Hornsea Project Three  
Offshore Wind Farm

Applicant's comments on Written Representations and  
Responses submitted by Interested Parties at Deadline 3

Date: 15<sup>th</sup> January 2019

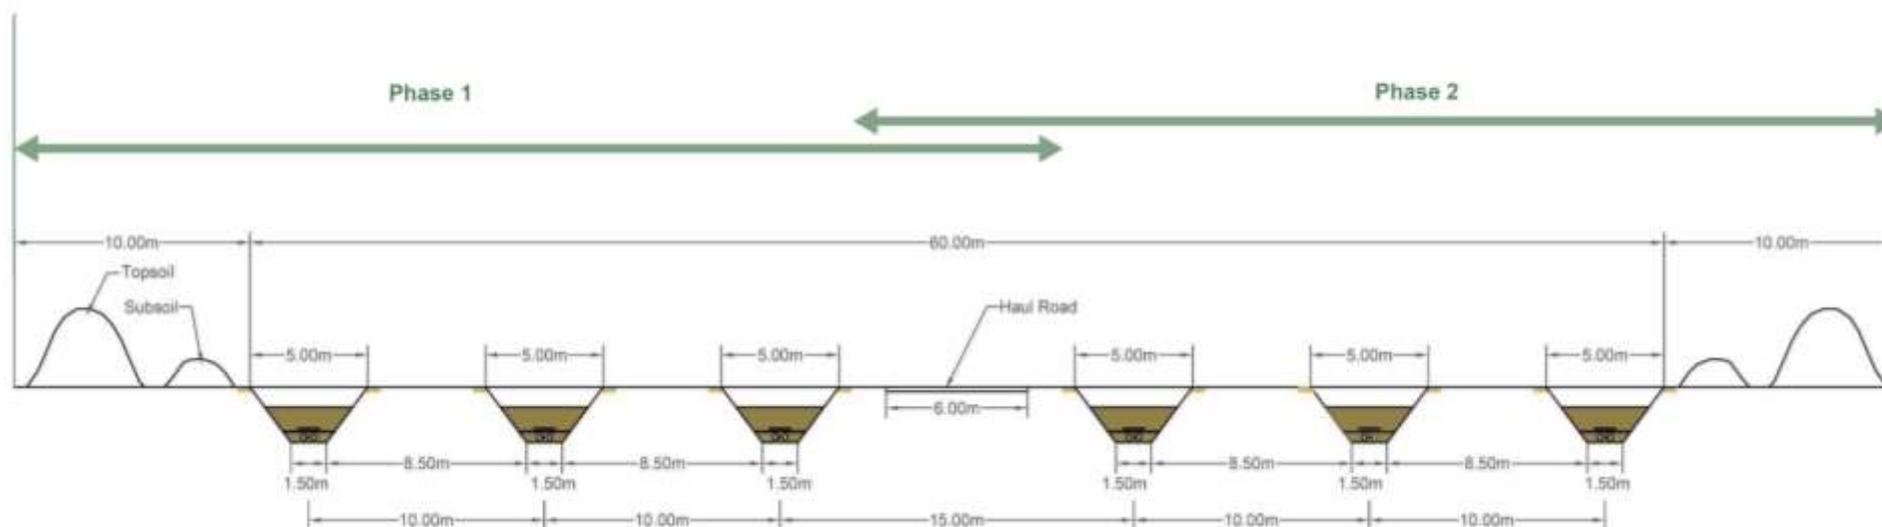
NE ISH4 Comment	Applicant's Response
	<p>constructed in two phases. Figure 1 attached to this document illustrates the potential width of each phase across the cable corridor if approximately 50% of Hornsea Three was constructed at phase 1 and 50% at phase 2. The areas where cables could be laid and soils stored temporarily on the outside of the corridor at phase 1 are unlikely to need to be disturbed again to install phase 2, and therefore hedgerows re-instated within this area immediately after completion of phase 1 would remain in place when phase 2 was constructed. Only the part of the phase 1 area which is required to construct both phases (e.g. the haul road) would need to be disturbed in both phases. Therefore, the majority of hedges across the 80m wide cable corridor would only be removed and replaced once.</p> <p>This, and other measures, will be designed in detail post-consent to ensure that minimal harm is caused to existing hedges and trees within the onshore cable corridor, and to minimise the extent of hedgerows that need to be removed and replaced twice.</p> <p>The Applicant is not able to commit to installing additional capacity within the AONB in phase 1 to accommodate both phases for reasons given in the Written summary of Applicant's oral case put at Issue</p>
